Hurricane Planning Commission Meeting Agenda

May 23, 2024
6:00 PM

Agenda Date:	05/23/2024
Application Number:	ZC24-05
Type of Application:	Zone Change Application
Action Type:	Legislative
Applicant:	Dylan Stratton
Agent:	Brandee Walker
Request:	A Zone Change from A-5 to RA-0.5
Location:	2250 S 5140 W
Zoning:	A-5
General Plan Map:	Planned Community
Recommendation:	Deny due to unlawful division of land.
Report Prepared by:	Fred Resch III/Gary Cupp

PRECISION HOMES -STRATTON PROPERTY
ZONE CHANGE EXHIBIT
LOCATED IN HURRICANE, UTAH

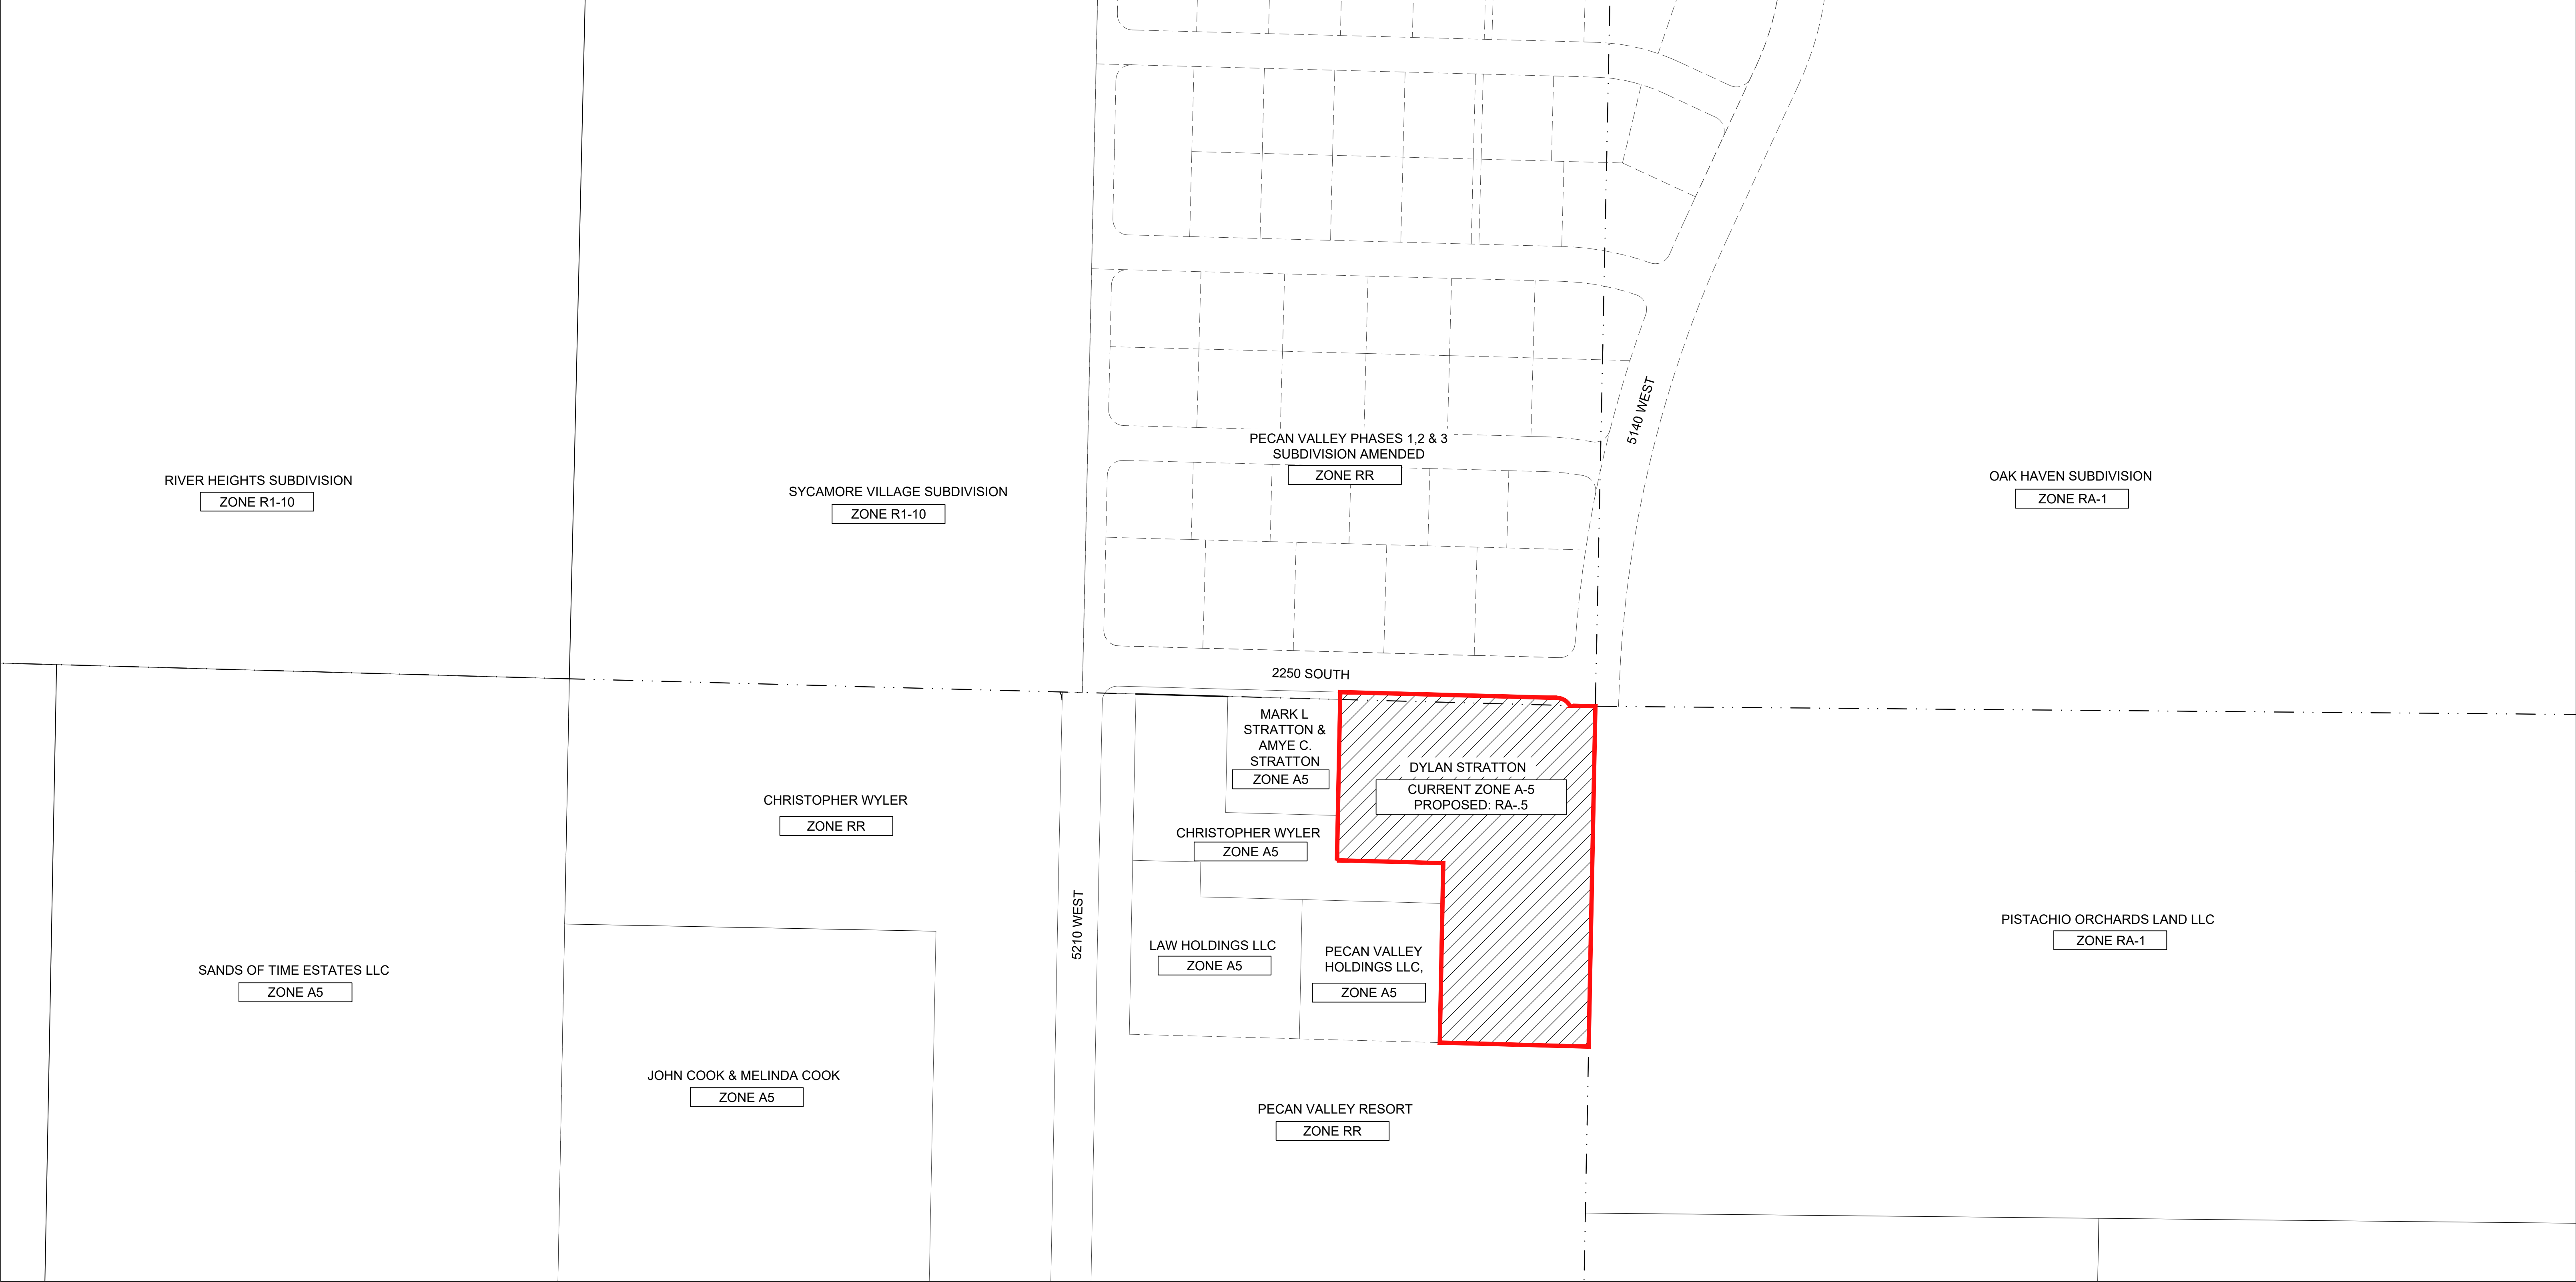
4. **Streets:** Okay
5. **Water:** Okay
6. **Engineering:** The applicant has been informed that 5140 W is a master planned roadway (a minor collector with a 12' trail on its east side, typical section: 67' wide). Higher densities near master plan roads help offset construction costs. Most facilities are adequate for the proposed zone and it's reasonable to expect that the property owner can shoulder the burden to rectify any deficiencies when they develop the property.

1. The applicant states their goal is to bring the property into zoning compliance. The subject property was subdivided by document [20240009437](#) without staff's approval ([HCC 10-39-4\(A\)](#)); as the property is traversed by a master planned road, this is of significant concern to staff. Furthermore, HCC 10-9-5 (E) states that reducing the lot area to make a lot nonconforming is a violation of this title and a Class B misdemeanor.

2. There is a 67'' master planned roadway (5140 W) that will need to be accounted for in any legal subdivisions of the property.
3. HCC 10-9-6 states:
 - a. *The City may deny or withhold all permits, certificates, or other forms of authorization pertaining to any land or improvements when an uncorrected violation exists pursuant to this title or to a condition or qualification of a permit, certificate, approval or other authorization previously granted by the City Council, Planning Commission, Appeals Board, or other City officer. The City may, instead of withholding or denying an authorization, grant such authorization subject to the condition that the violation be corrected. The provisions of this section shall apply regardless of whether the original applicant or current owner is responsible for the violation in question.*

Recommendation: The Planning Commission should review this application based on standards within the Hurricane City Code, and also consider any public comments. Staff recommends that this zone change request be denied at this time due to the unlawful division of the property.

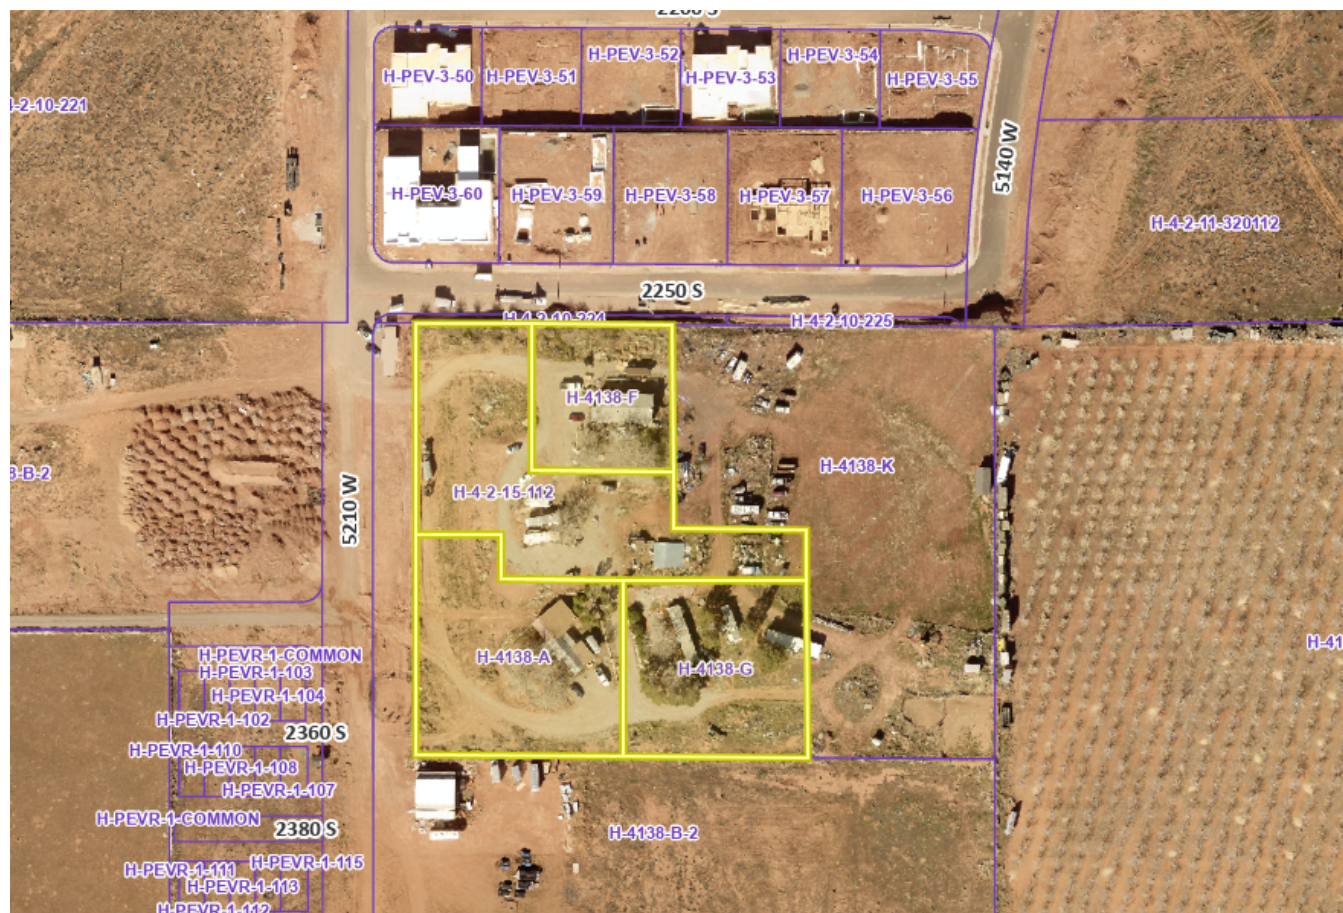
Engineering: The preliminary site plan should indicate how the historic access to the neighboring parcel H-4138-G will be preserved or replaced (HCC 10-7-10(D)(2)). A portion of the area in this zone change exhibit was subdivided from a neighboring parcel without a plat or staff's approval (HCC 10-39-4(A)). Applicant needs to review our on-street parking ordinance (HCC 10-34-8(J)). Public street should be extended to property lines (HCS 2.1(bullet 2)) & turnaround can be protected by easement. The preliminary site plan shall include a preliminary storm drain plan (HCC 10-7-10(D)(2)(A)(5)) This project information causes viewers to consider that what's shown here is a separate project. "recreation resort zoning shall contain a minimum of five acres" - HCC 10-26-5(A)(3) a clubhouse is required for 0-99 units - HCC 10-26-4(A). A brief summary of the amenities being provided in other portions of the resort, a ratio of units per amenity, a comparison of entitled units to proposed units could go a long way.

Recommendation: The Planning Commission should review this application based on standards within the Hurricane City Code, and also consider any public comments. Staff recommends that this zone change and preliminary site plan request be denied at this time due to the unlawful division of the property and due to outstanding quit-claims for sliver parcels H-4-2-10-224 and H-4-2-10-225.

Hurricane Rehab Center

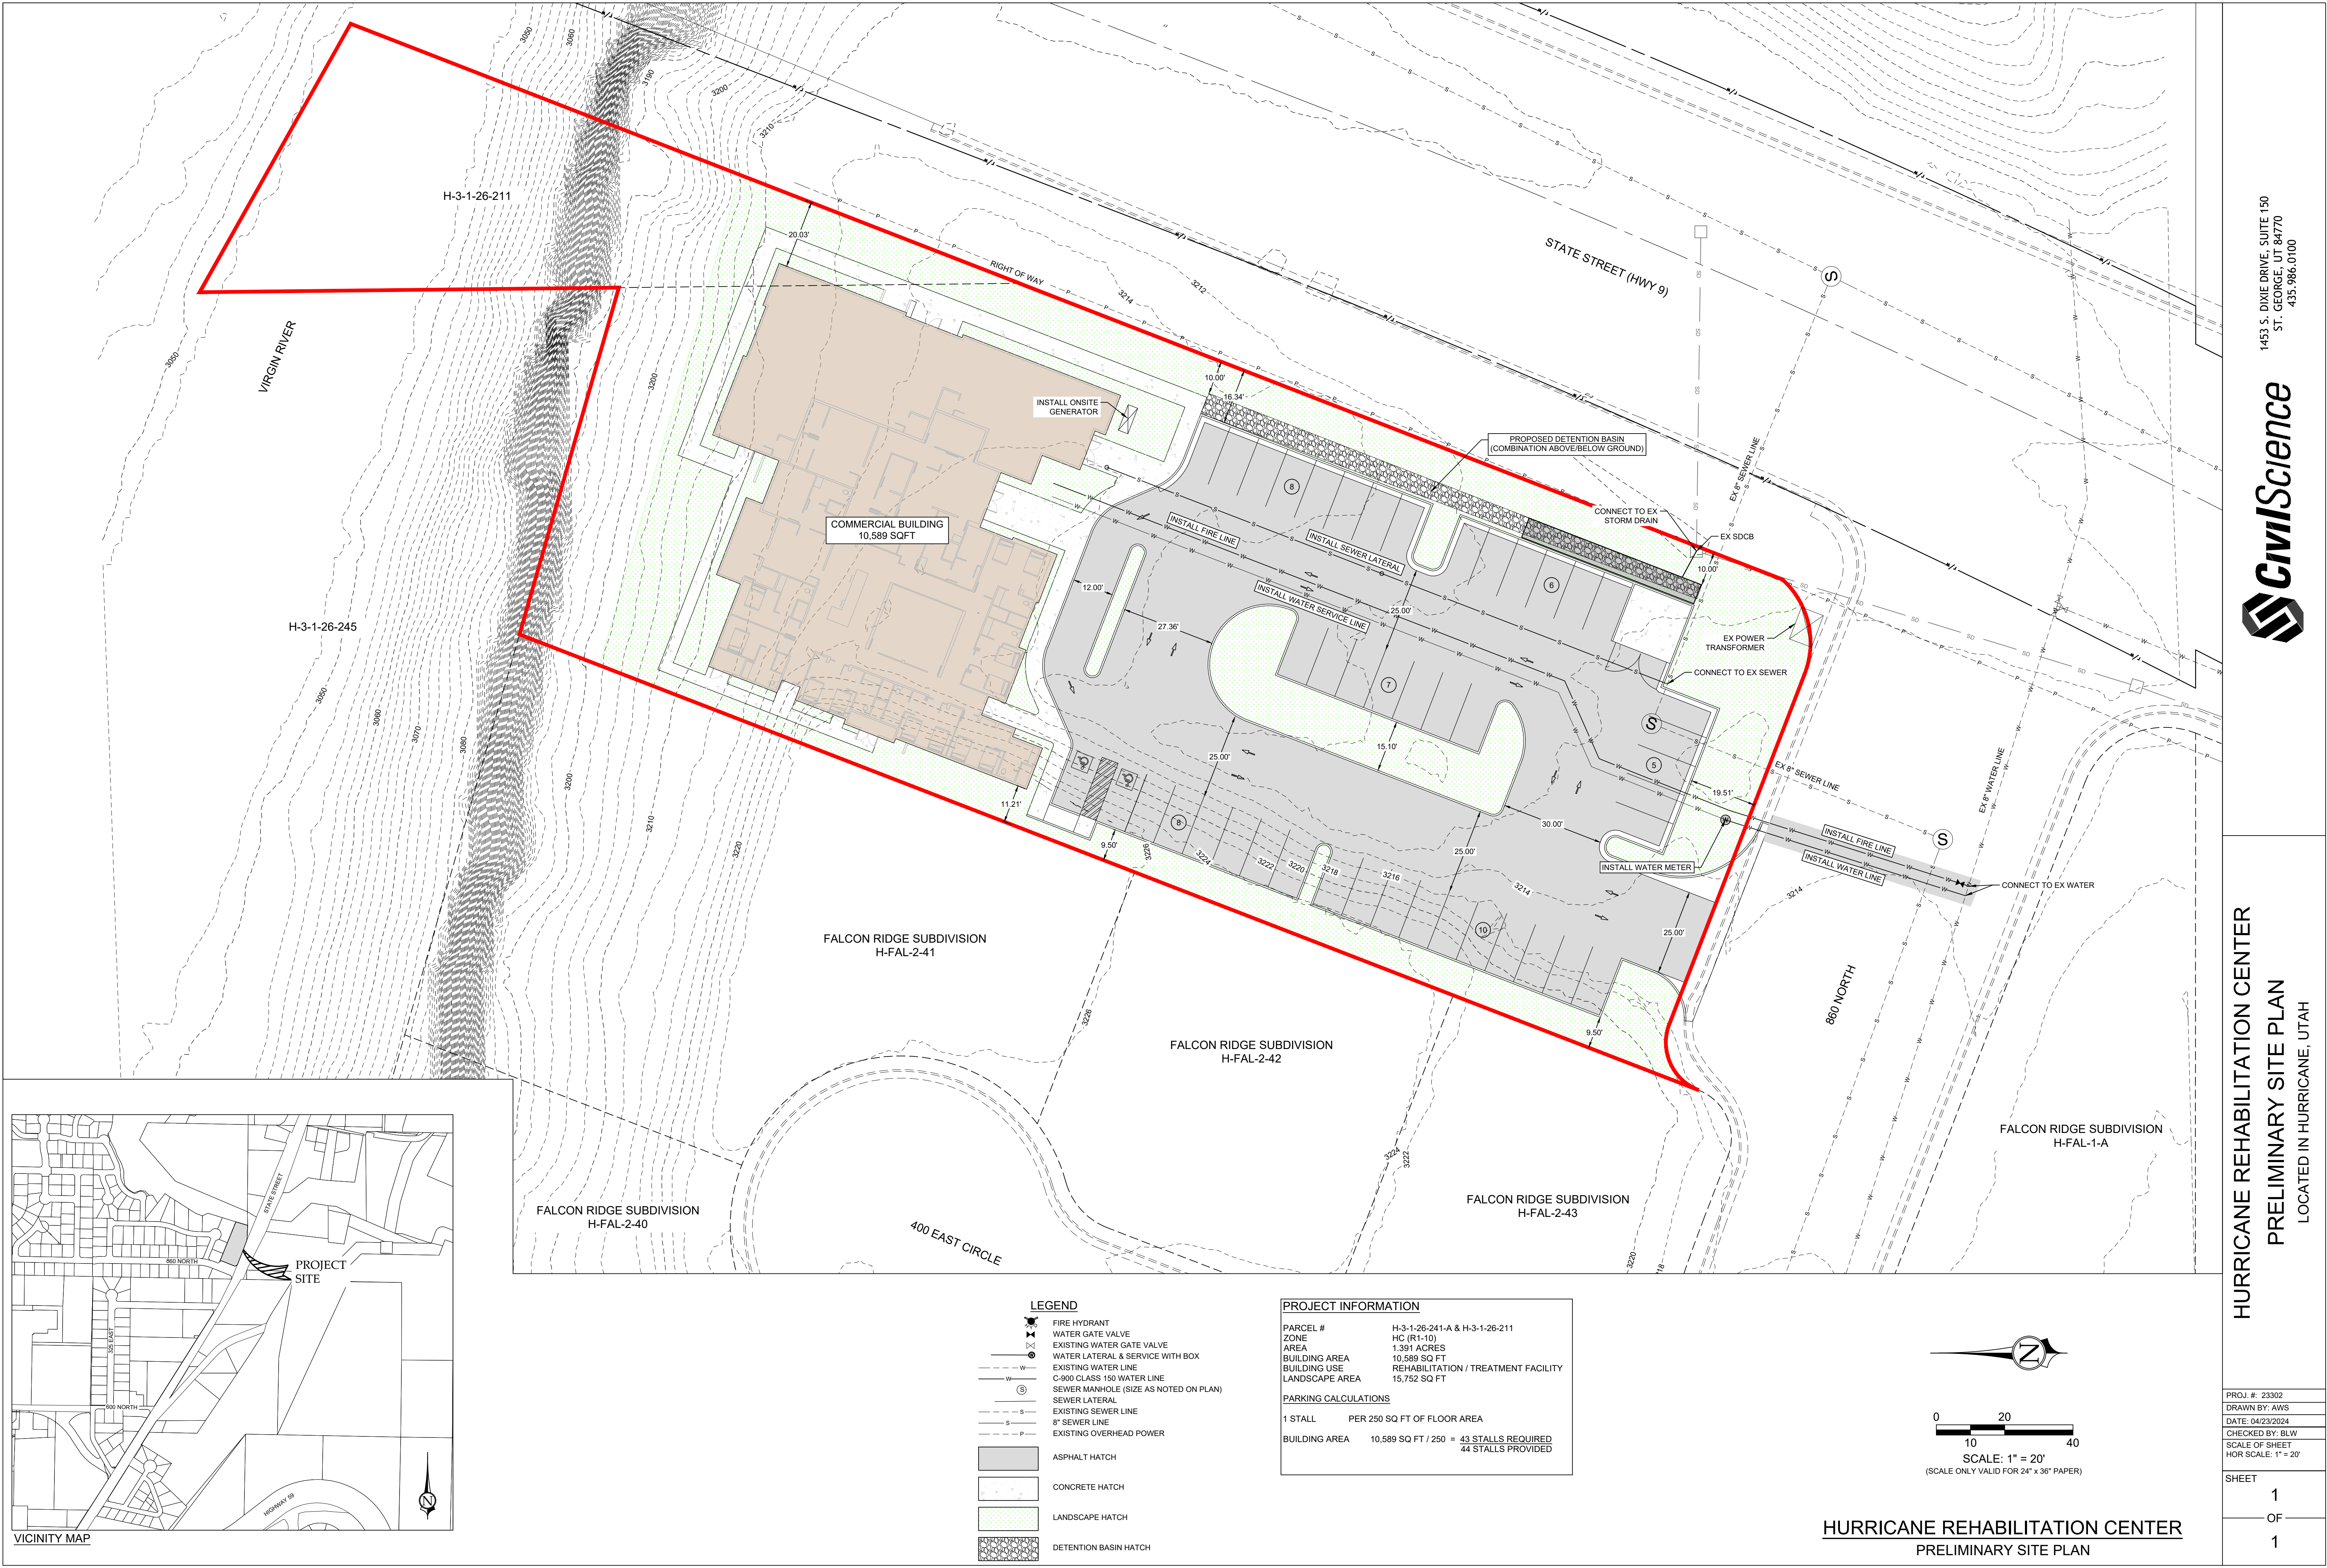
3. **Water:** Okay.
4. **Street:** No comments
5. **Sewer:** No exception
6. **Engineering:** Some *existing* features haven't been depicted in this drawing (e.g. 8' cross gutter, 16"Ø pressure sewer main, buried power, overhead power, guy wires and power pole, the bridges' median, jersey barriers, crash cushion, rip rap, and storm drain inlets). Accurate depictions of existing conditions is vital for scoping a project. The roadway improvements to State Street are expected to follow the ideal right of way width SR-9 major arterial downtown Hurricane cross

section on pg. 26 of the Active Transportation Plan (i.e. 8' sidewalk 5.5' from the back of the existing curb and gutter.) A short length of sidewalk between the public sidewalk on State Street and the internal walkways would do a lot for HCC 10-33-5(H). Engineering would support a proposal to declare surplus property and reconfigure public improvements for said property; the existing roadway is excessively wide, underutilized, and the use of 860 N isn't forecasted to perceptibly increase. Nevertheless, the applicant/property owner and the City Council must make the agreement (see HCC 1-10-2). Although the access is from the lesser-classified road and it appears the access is near the greatest distance possible from the intersection of SR-9 and 860 N it appears the access isn't fully compliant with HCS 3.2.4.2(H). The table of said city standard specifies that exceptions can only be approved by the city engineer upon submission of proper traffic justification. Retaining walls must be added to this plan to realize the proposed layout (HCC 10-7-10(D)(2)). Engineering would recommend that the property owner conveys the unbuildable areas of the site (areas with 30% and greater slope [HCC 10-24-6(A)] and areas within the Virgin River Floodway [HCC 10-28-3(D)] to Washington County, the neighboring property owner. The applicant's engineer must show and identify the unbuildable slope and 25' setback from the edge of the bluff (HCC 10-24-7(A)(9)(A))

Recommendation: The Planning Commission should review this application based on standards with Hurricane City Code. Staff recommends approval of this preliminary site plan subject to JUC and staff comments.
